SUBJECT: Safety Recall 05S28 - Supplement #6
Certain 1994-1996 Model Year Bronco, 1994-2002 F-150/250 (Under 8500 GVW), 1997-2002 Expedition, 1998-2002 Navigator, and 2002 Blackwood Vehicles Equipped With Speed Control
Speed Control System Modification

SUBJECT: Safety Recall 05S28-S7
Certain 1994-1996 Model Year Bronco, 1994-2002 F-150/250 (Under 8500 GVW), 1997-2002 Expedition, 1998-2002 Navigator, and 2002 Blackwood Vehicles Equipped With Speed Control
Speed Control System Modification

SUBJECT: Safety Recall 05S28 - Supplement #9
 Certain 1994-1996 Model Year Bronco, 1994-2002 F-150 through F-550, 1997-2002 Expedition, 1998-2002 Navigator, 2002 Blackwood, 1994-1996 E-150/250/350, 1996-2002 E-450, 2000-2002 Excursion, and 1998 Explorer and Mountaineer vehicles equipped with Speed Control – Speed Control System Modification

FIGURE 1

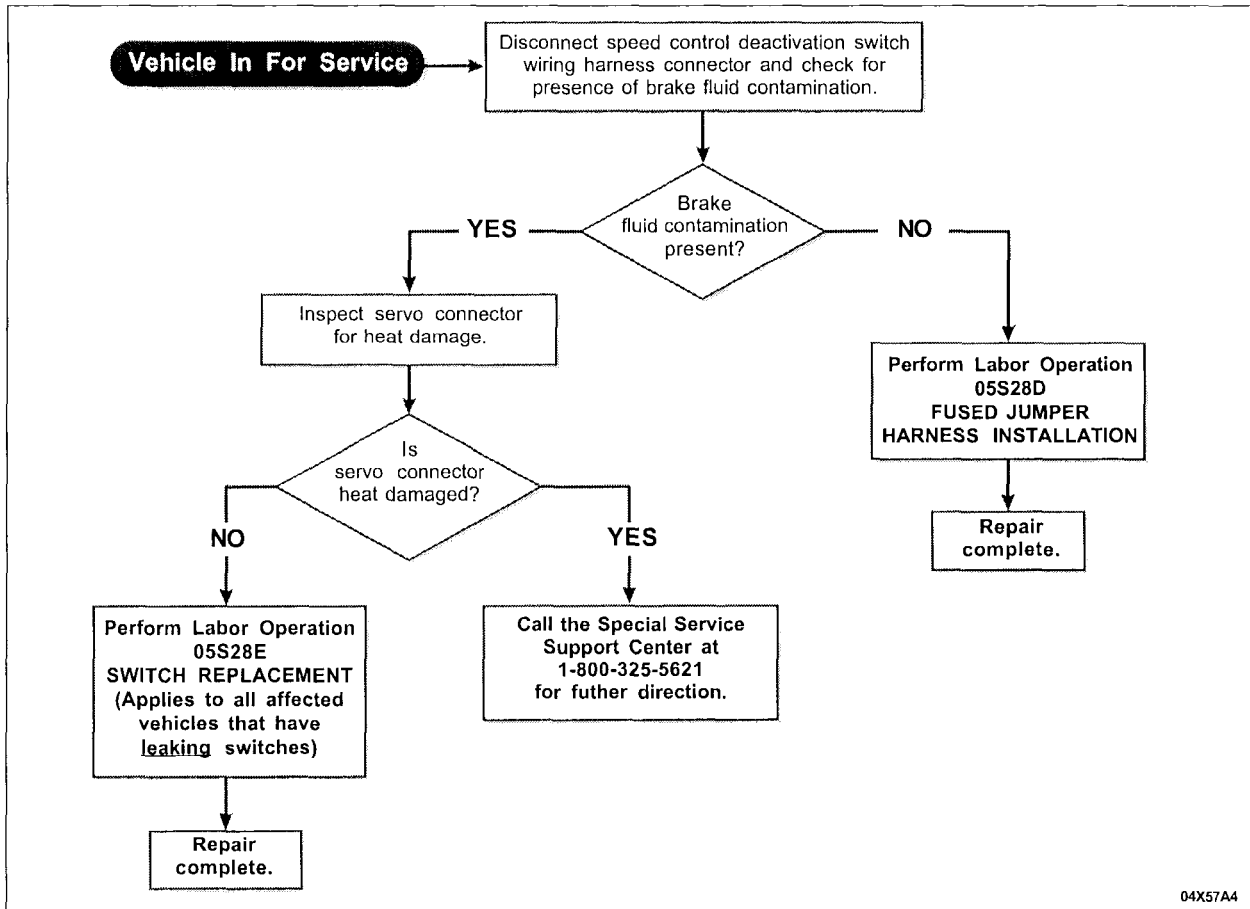
This program involves performing an inspection procedure to determine which repairs to the speed control system must be performed; either installation of a fused jumper harness or replacement of the speed control deactivation switch. A flow chart has been developed to direct you to the proper service actions. See Figure 1.

NOTE: Disconnecting the battery is no longer required when performing these repairs.

FIGURE 4

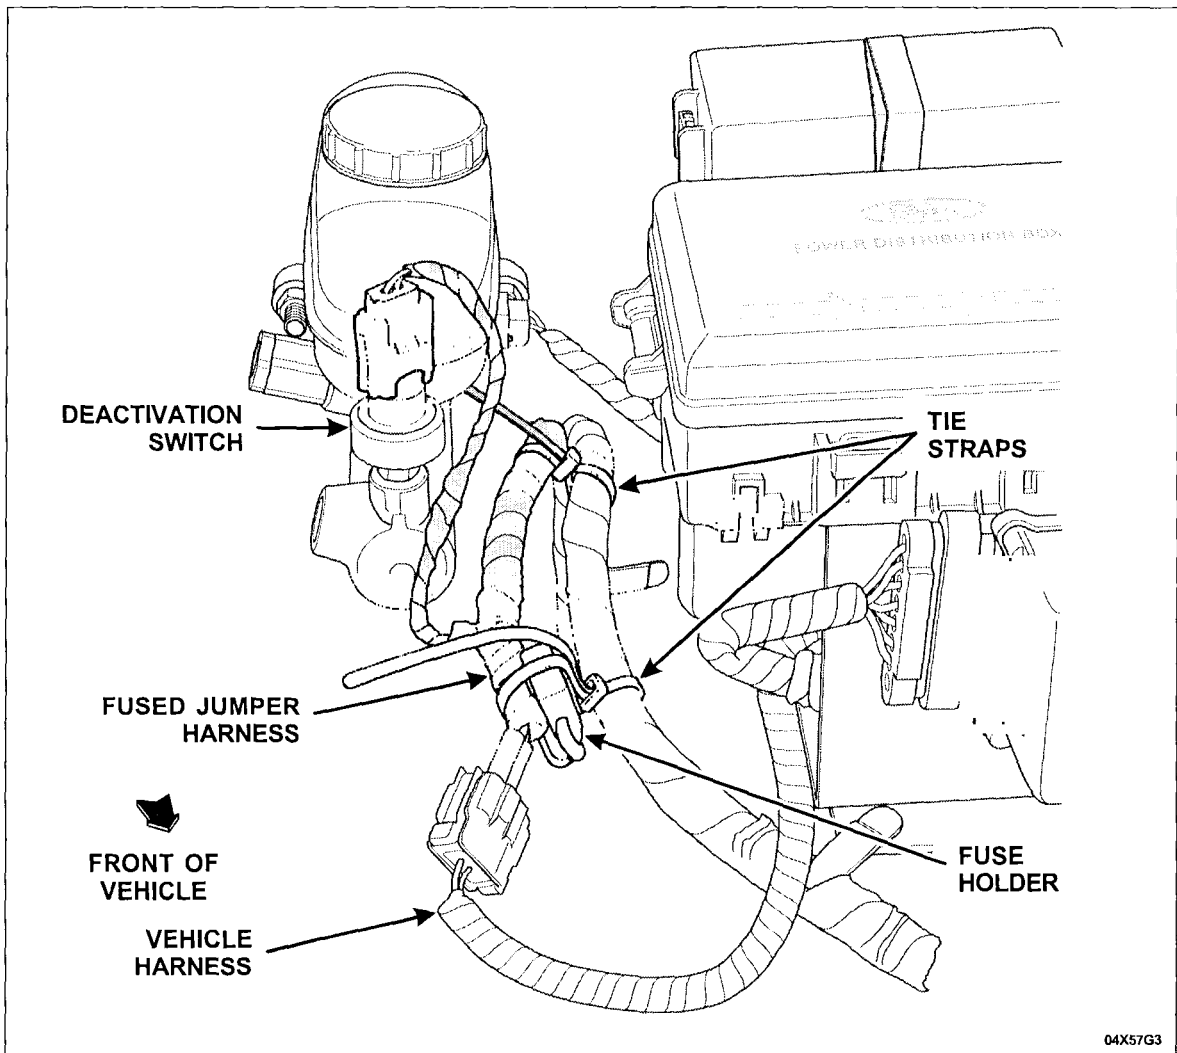
LABOR OPERATION D – APPLIES TO VEHICLES WITH NON-LEAKING SWITCHES

1.
 - a) Connect the fused jumper harness (14A411) to the speed control deactivation switch and the vehicle harness.
 - b) Position the harness alongside the existing harness, located below the master cylinder, so that the fuse holder is higher than the rest of the jumper harness. This will cause any water that enters the engine compartment and gets on the jumper harness to run downhill away from the fuse holder.
 - c) Secure the jumper to the existing harness with tie straps, making sure the fuse holder is positioned vertically with the cap facing upwards. Wrap the tie straps underneath, then over the top of the existing harness and verify proper fuse holder orientation. See Figure 4.
2. Release the vehicle.

FIGURE 4

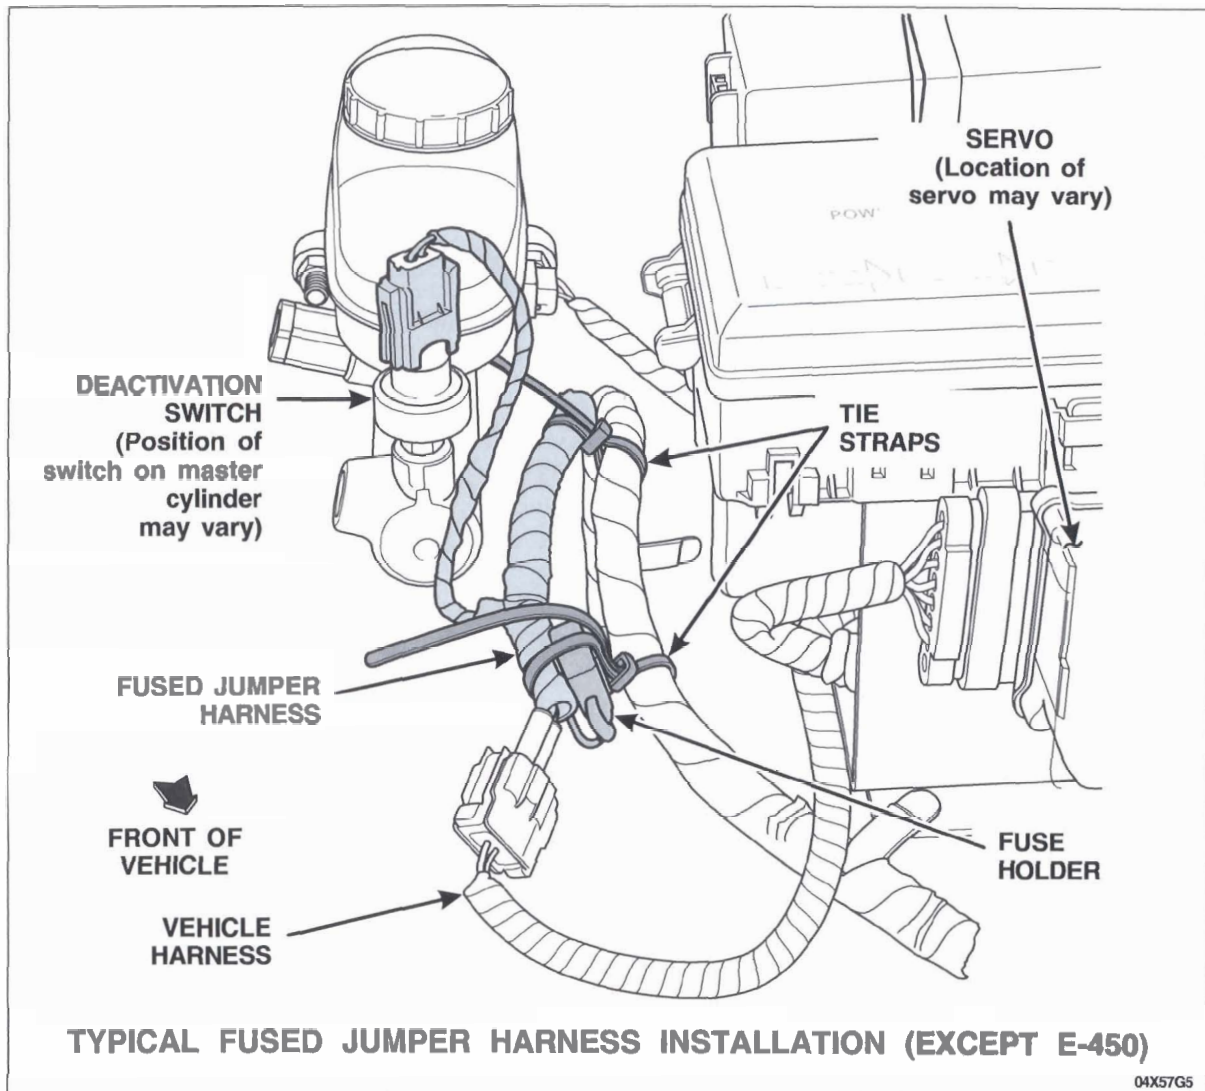
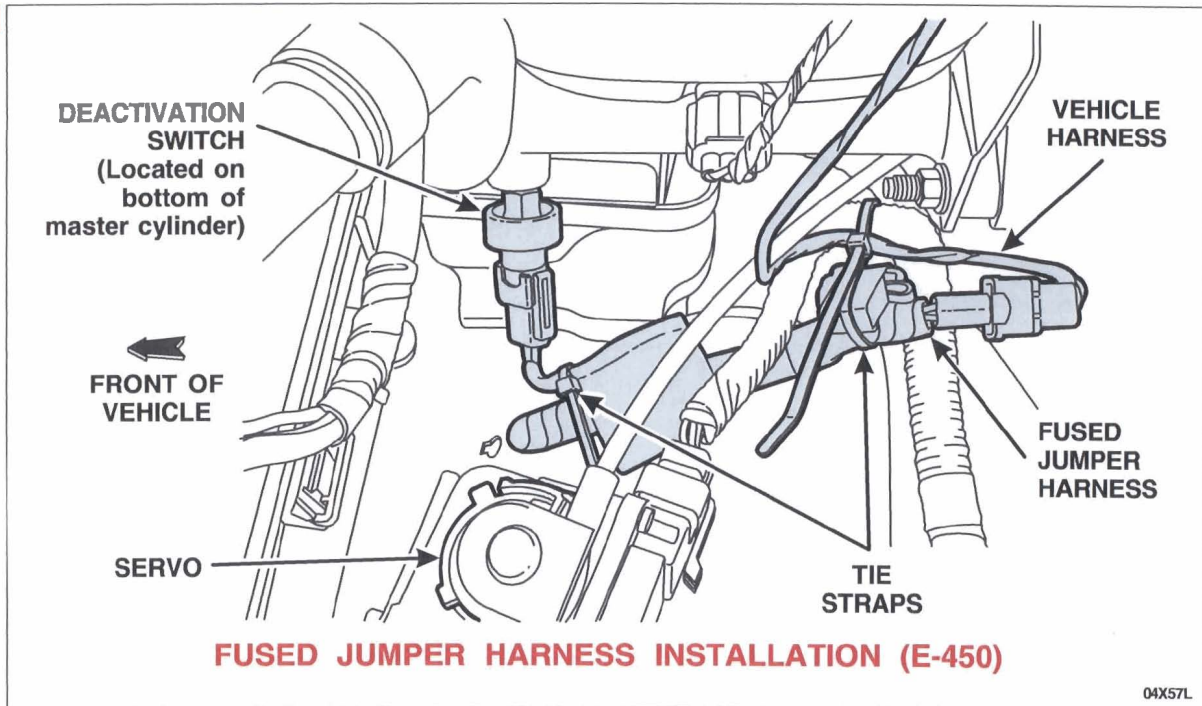
1. Connect the fused jumper harness (14A411) to the speed control deactivation switch and the vehicle harness.
2. On E-450 models, secure the 2-wire take out to the larger portion of the fused jumper harness before installation, as shown in Figure 5.

4. Secure the jumper to the existing harness with tie straps, making sure the fuse holder is positioned vertically with the cap facing upward. Wrap the tie straps underneath, then over the top of the existing harness and verify proper fuse holder orientation. See Figures 4 and 5.

FIGURE 7

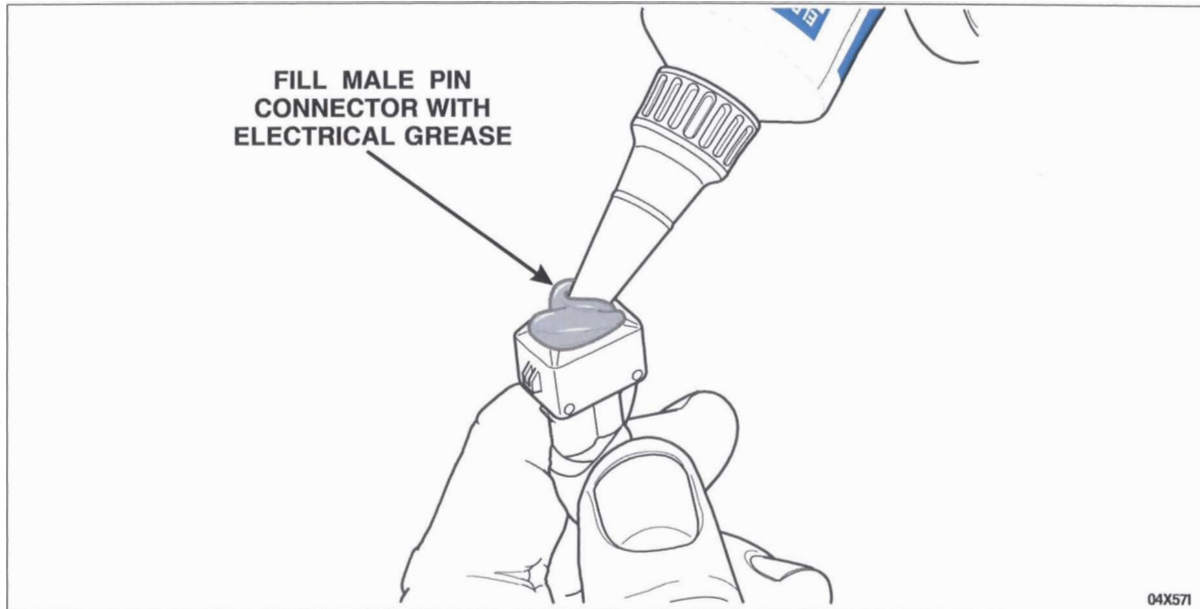
3. Install the *new* speed control deactivation switch into the master cylinder and tighten to 18 Nm (13 lb-ft).
4. **With the speed control servo disconnected, use shop air *only* to blow the speed control deactivation switch harness electrical connector and the servo connector dry of any trace of brake fluid. DO NOT USE ANY TYPE OF SOLVENT TO CLEAN THE CONNECTORS.**
5. Cut approximately 3 mm (1/8 in) off the grease tube applicator tip.
6. **Before installing the jumper harness, fill the vehicle harness end of the jumper (male pin connector end) with Motorcraft Electrical Grease II XG-15-A. See Figure 7.**

FIGURE 8

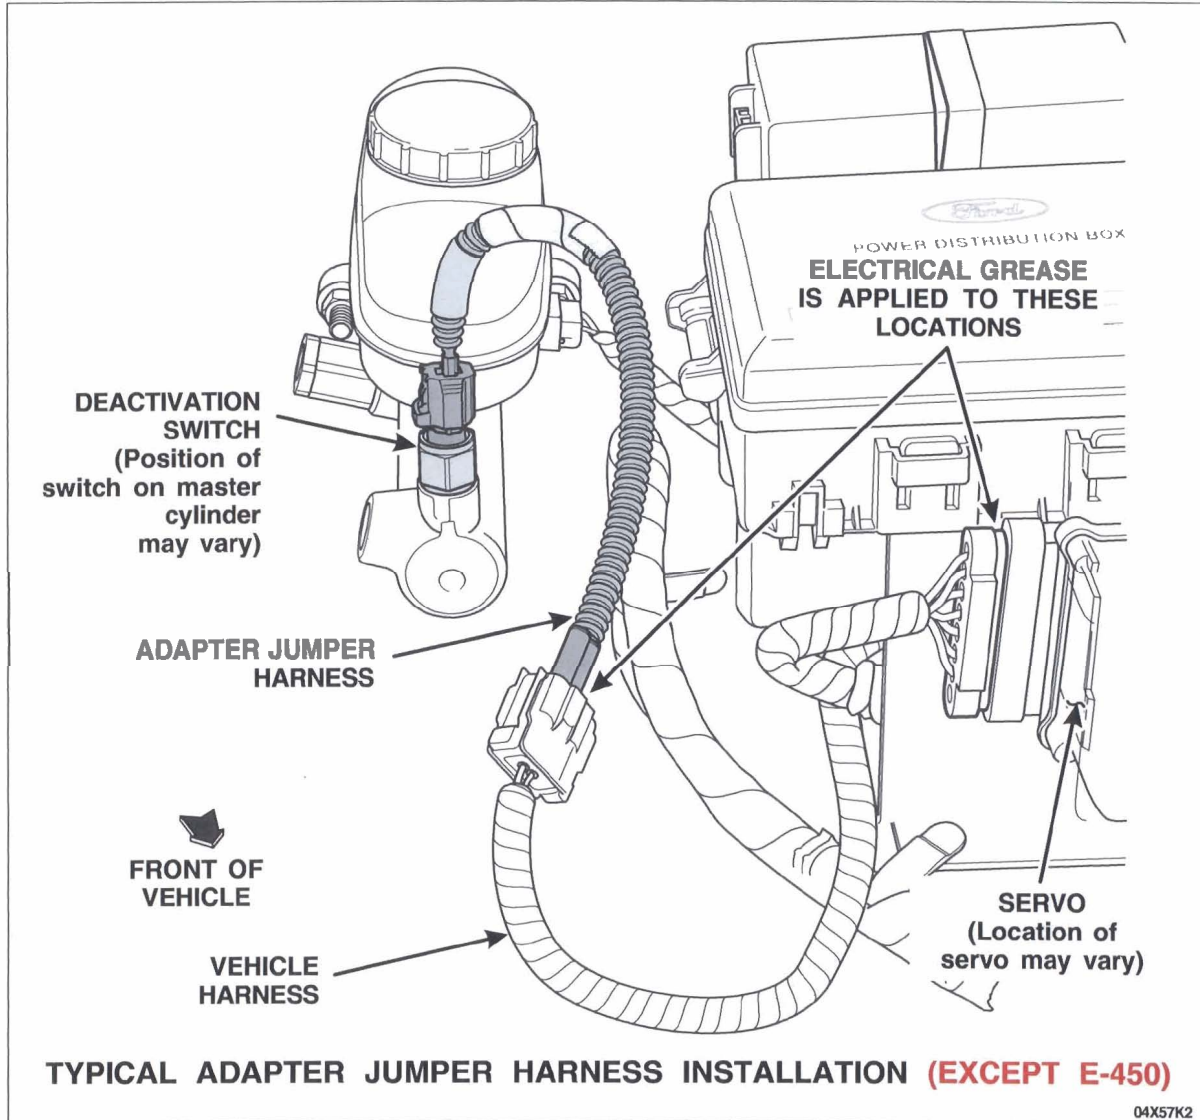
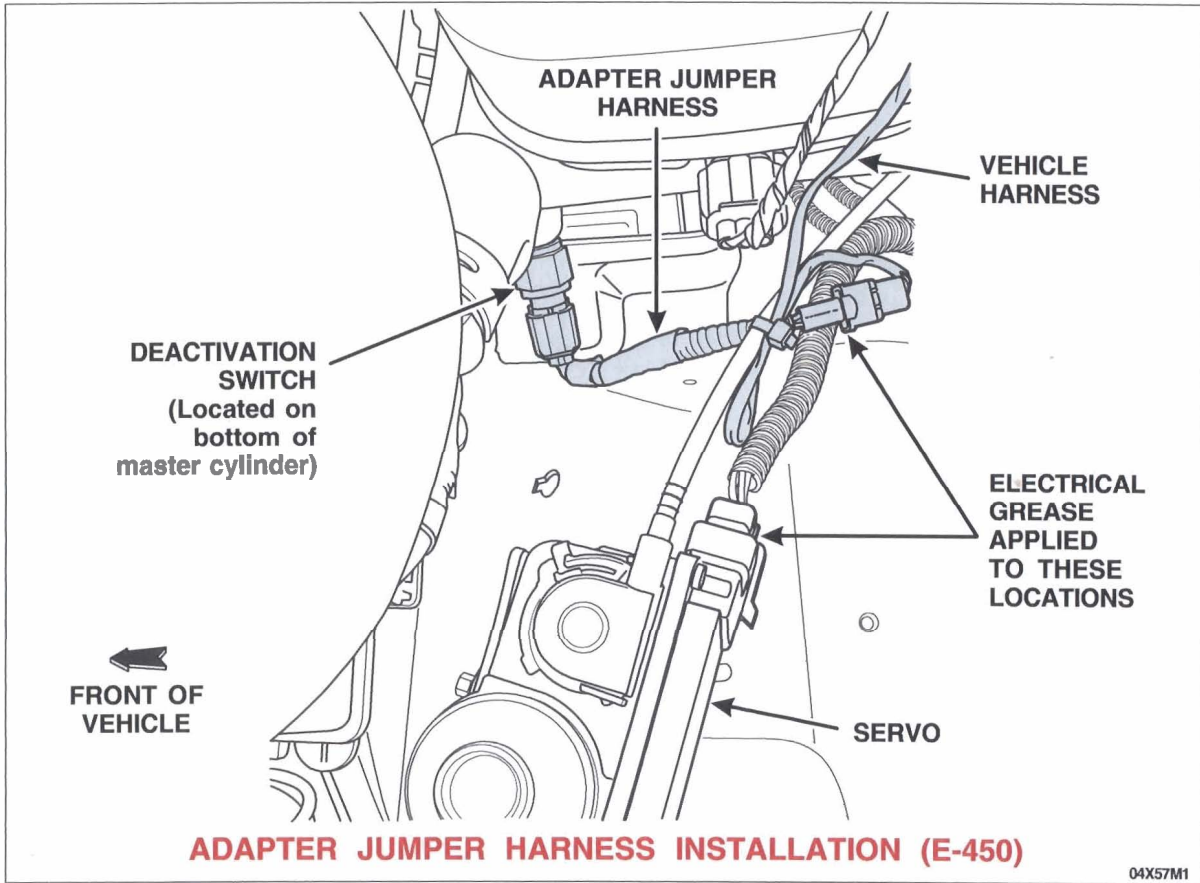
7. Install the adapter jumper harness by connecting it to both the deactivation switch and the vehicle harness. Using the provided tie strap, secure the jumper harness to a nearby component such as the speed control cable or another wire harness. See Figures 8 and 9.

FIGURE 10

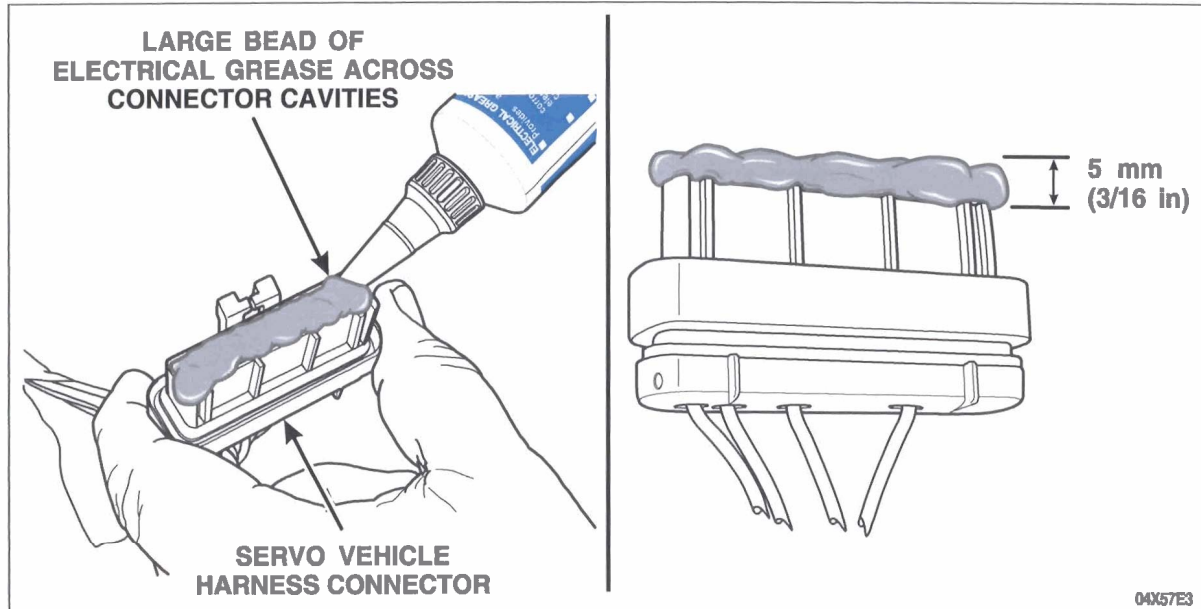
NEW

Apply a 5 mm (3/16 in) high bead of Motorcraft Electrical Grease II XG-15-A across the entire width and length of the servo vehicle harness connector. See Figure 10.
